## ADDENDUM TO THE CONTRACT

### Second Street Reconstruction Contract No. E11-152

**ADDENDUM NO.:** ONE

**DATE ADDENDUM ISSUED:** February 17, 2011

1 2-INCH WATER SERVICE @ 1106 2ND STREET  
N.T.S.

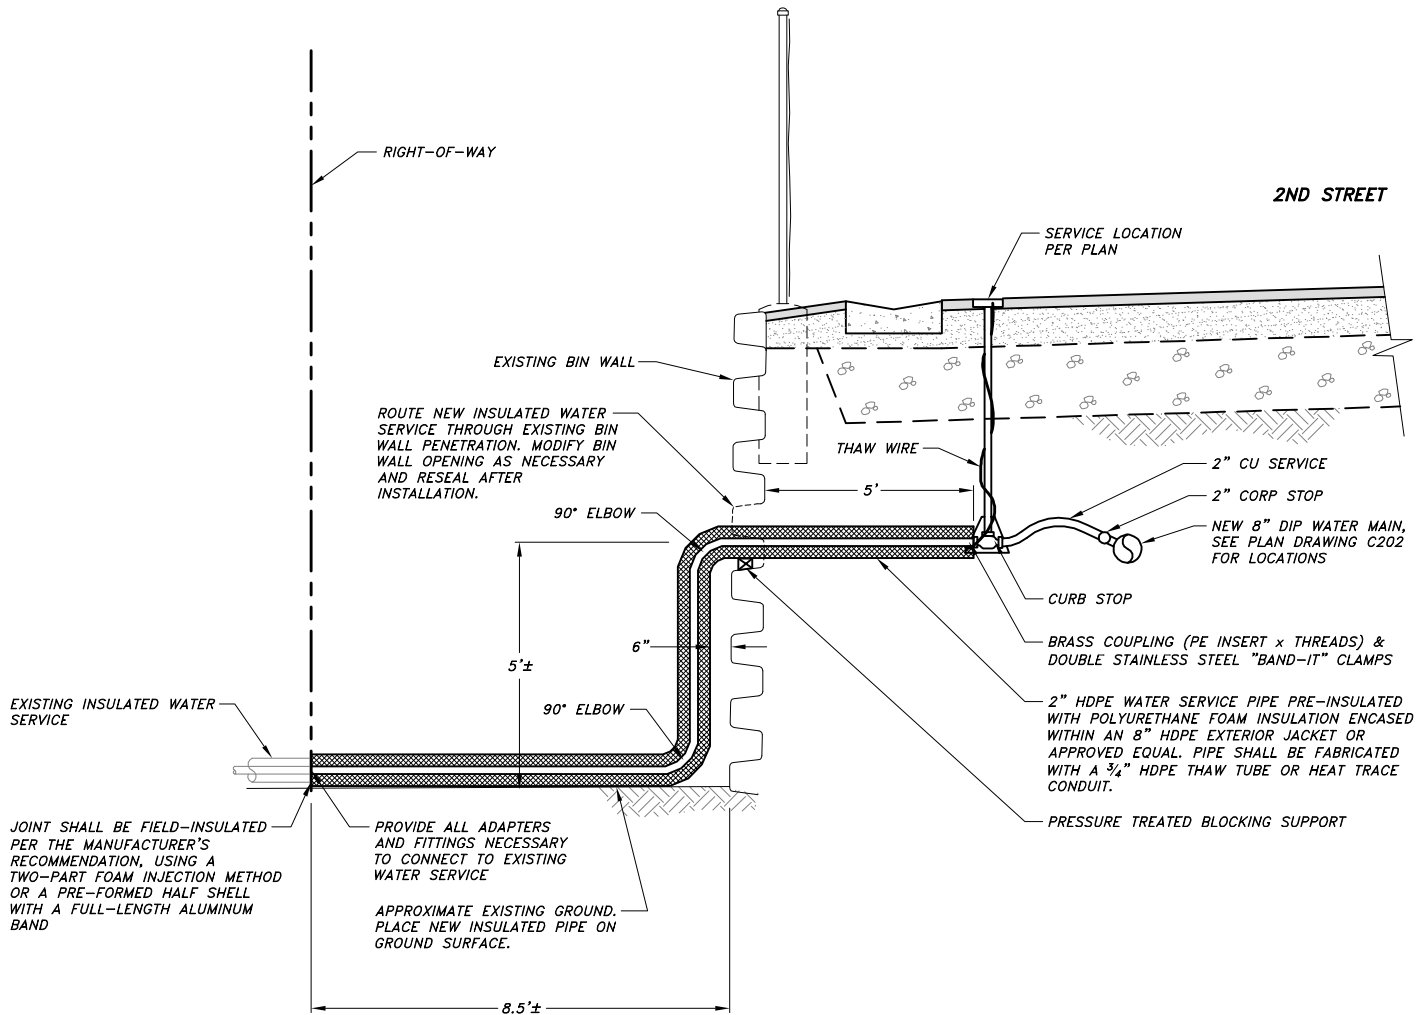
Item No. 1 SECTION 01025 – MEASUREMENT AND PAYMENT, Article 2.25 (-)Inch Water Services, **delete** paragraph D, and **replace** with the following:

D. No measurement for payment will be made for the work required to remove the existing insulated water pipe, installing new insulated water pipe including connecting to the existing water service, sealing and insulating at the connection point, coordinating with the 1106 Second Street property owner for the installation of the heat trace wire, supporting the insulated water pipe and other WORK as shown in the Addendum No. 1 drawing dated February 17, 2011. This WORK shall be incidental.

Item No. 2      Add the attached Addendum No. 1 Drawing titled "2-Inch Water Service @ 1106 2<sup>nd</sup> Street" dated February 17, 2011, Sheet 1 of 1.

1. ALIGN NEW SERVICE SO THAT HORIZONTAL OFFSET BEND IS NOT REQUIRED.
2. ALL FIELD PIPE JOINTS SHALL BE CONNECTED AND INSULATED BY A METHOD APPROVED BY THE PIPE MANUFACTURER.
3. REMOVE AND DISPOSE OF EXISTING INSULATED PIPE FROM THE PROPERTY LINE TO THE NEW WATER MAIN.
4. CONTRACTOR SHALL COORDINATE WITH THE OWNER OF 1106 2ND STREET ON CONNECTION OF THE EXISTING HEAT TRACE WIRE TO THE NEW INSULATED PIPE HEAT TRACE SYSTEM.
